ACP-2019-01 London Stansted FASI-Stage 2 Develop & Assess Points Requiring Clarification

SID RWY22 EAST

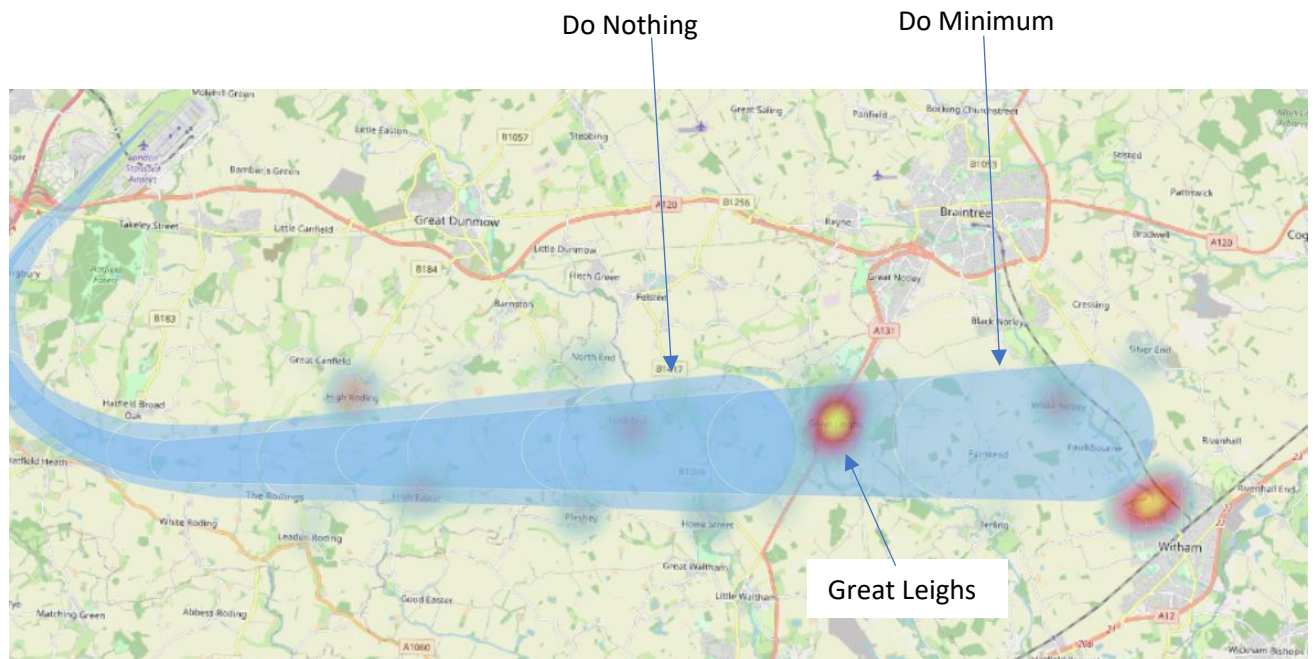
Para 3.7.1 of the Initial Options Appraisal (IOA) Report states that if the Do-Minimum is implemented there will be “little change when compared to the lateral track flown by aircraft in today’s operation [i.e. the do-nothing baseline]”. However, the IOA shows a difference of up to 1000% between the Do-Nothing baseline and the Do-Minimum for some design options. Please therefore clarify the difference in overflight between the Do-Nothing baseline and Do-Minimum options (see examples below in Table 1). Similar discrepancies have been identified for the fuel burn and greenhouse gas assessments within the IOA (e.g. SID RWY22 North).

- 1.11. To illustrate the above explanation as to climb gradients, the above map shows that the 'do minimum' track has a lower rate of climb to 7000ft than the 'do nothing', which makes the overflight path longer. As a result, the path then flies over Great Leighs, causing the difference in population overflown for this SID.
